# Contents of Addendum

# 1.1 Purpose of this section

This Addendum provides further explanation of the Stage 2 bid proposals submitted by United House on 21st June 2013. It responds in particular to comments received on our June proposals and suggestions made in the course of recent dialogue meetings. It also contains variant proposals to illustrate the implications of potential changes to our Stage 2 proposals.

Town Hall Plan Level 3

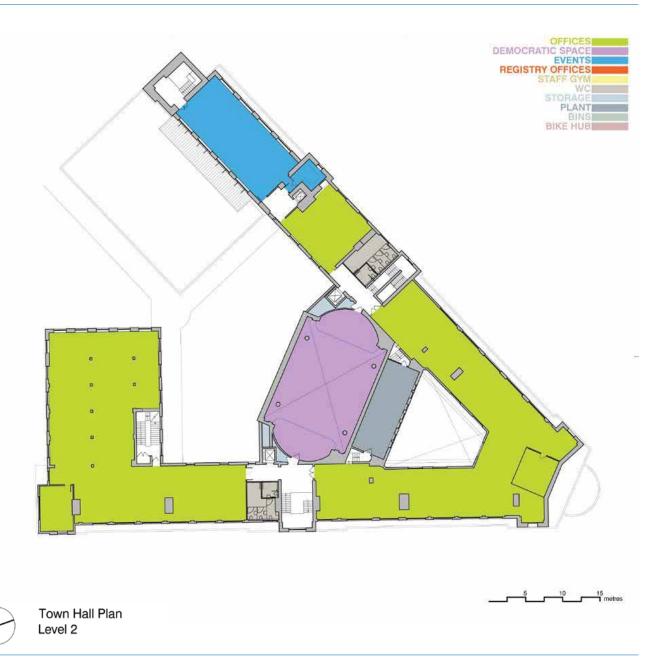
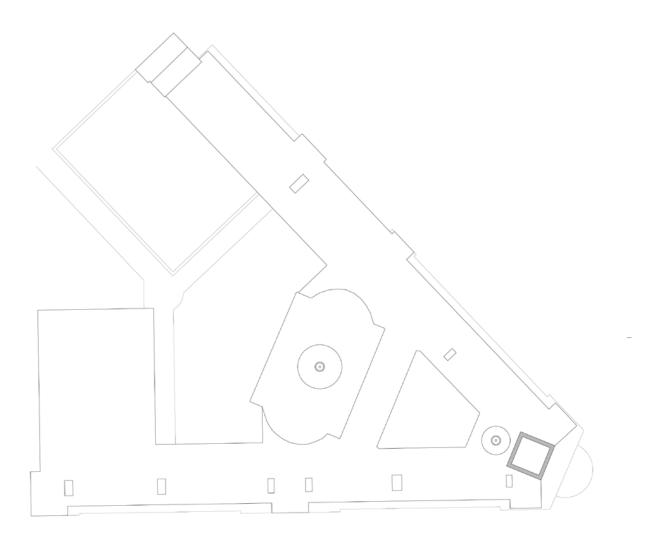
Concept fine. Need a bit more information on the roof top extension on the roof of the public hall. Not convinced the basement accommodation is appropriate for offices given the limited natural light. Use of the main town hall entrance primarily for the registrars is a good idea. Public access to the council chamber not shown in the space management / access plans.

Please see our various clarifications above regarding the rooftop extension, the basement and the entrances. Regarding access to the Council Chamber we propose that the Acre Lane stair and new lift will link the public zone on the ground floor (main entrance and registry office and Assembly Room entrance) to the Council Chamber. For specific events staff will also oversee public access via the ceremonial stair to the Chamber and the gallery.

### Hambrook Gardens - revised Bid Scheme and Variants 1, 2, 3

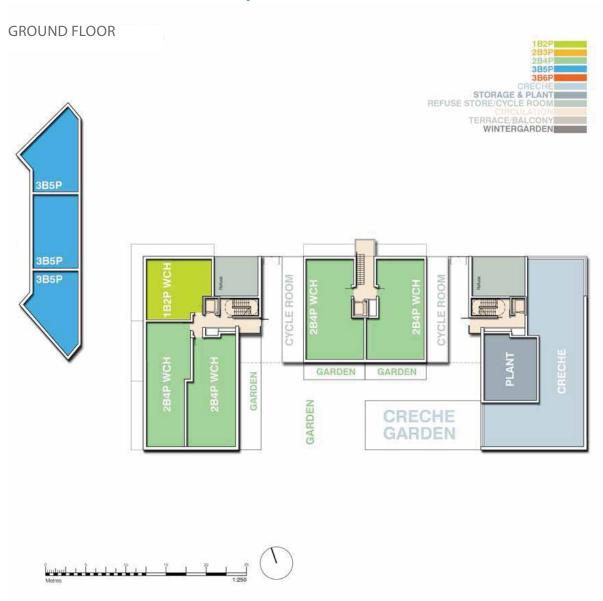
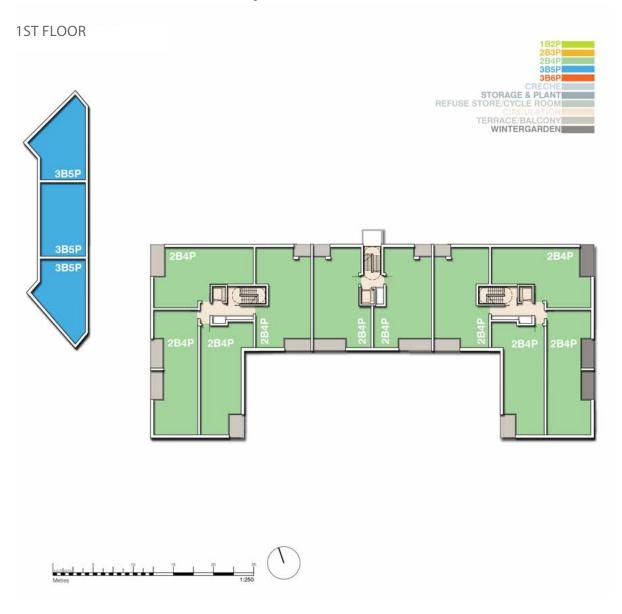
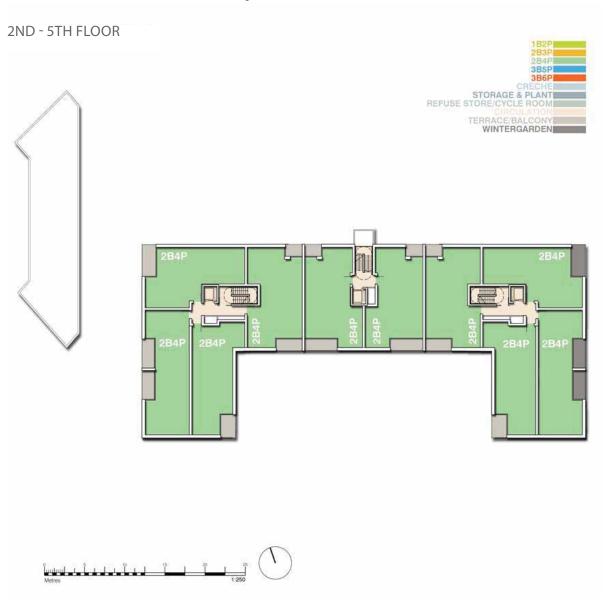
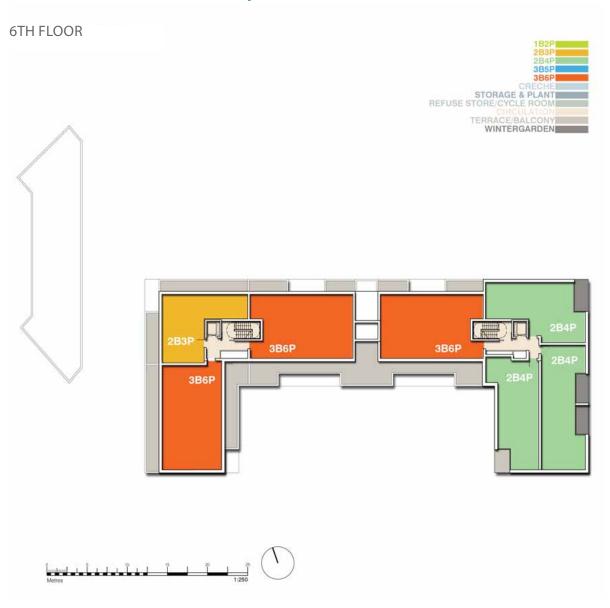
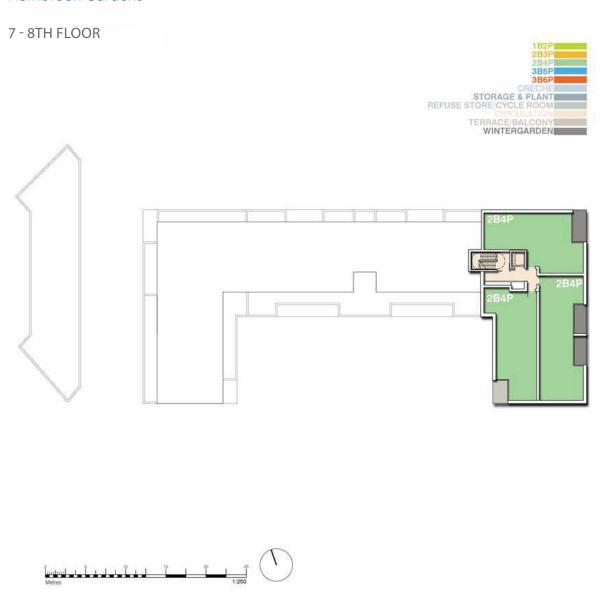
- Additional floor to Brixton Hill frontage of Hambrook House site may be supportable subject to appropriate design treatment. Question why rear element of scheme isn't increased by an additional storey.
- Question why 'Porden Mews' is only developed to 2 storeys. May be scope for some 3-4 storey element.
- Summary: Interventions to Brixton Hill frontage raise concern and would require further intensive dialogue with Council officers. Proposed massing/bulk of flexible accommodation to The Hub carries a degree of risk and is unlikely to be supported due to amenity concerns.

Would question the bidder's assertion that any more than one additional storey would weaken the justification of the Brixton Hill offices as a special case. The failure to explore a taller residential building hasn't been properly justified in the submission. (p20)

This shows one additional floor compared to our Stage 2 proposals. This would cover the whole of Hambrook Gardens.

We also show the option of two further floors to the Brixton Hill frontage only. This would take the building height to nine storeys and approx 29m.

As discussed we e have incorporated additional height at seven storevs overall and nine to Brixton Hill. However, we are aware of the sensitivity of neighbouring properties at Arlington House and Porden Road - and the feedback from residents at the Co-production Day. We are happy to pursue additional height, but consider that this adds some planning risk, both in terms of impacts on neighbours and in relation to the Town Hall and Conservation Area context.

### Olive Morris House section - Stage 2 Submission (June 2013)

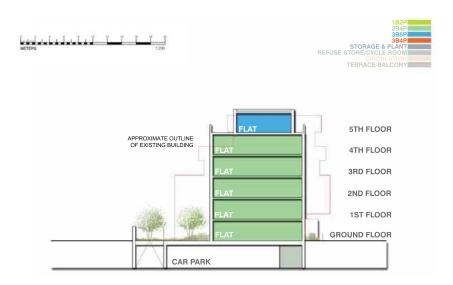
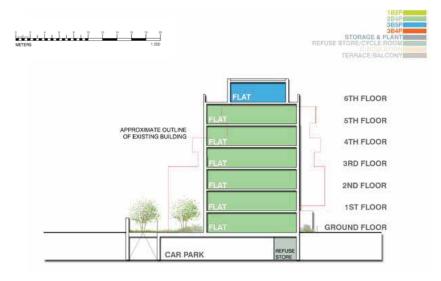
- Height and massing of New Council Building appears excessive, and would be difficult to support in design and heritage terms due to its monolithic appearance relative to Town Hall to the north. Building is too blocky and is overly dominant within the submitted massing views (especially Porden Road or from Town Hall junction (looking south)). Would fail to respect the townscape setting on Brixton Hill. Would carry a relatively high degree of planning risk
